N9918A-02

S E R V I C E N O T E

N9918A FieldFox Handheld Analyzer

Figure 1: Image showing the good and bad inductor on location U678 at RF Board

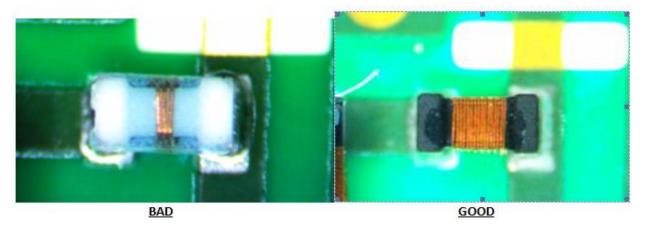
FieldFox instruments with the serial numbers listed below may show potential DANL failures with 3-4 dB difference due to misloaded inductor on the RF board. If DANL improvement is necessary, a new RF board is available to fix this it.

Affected FieldFox with necessary DANL improvement are required to send back to Agilent factory for a new RF board replacement. Test and Adjustment shall be done before shipping back to customer.
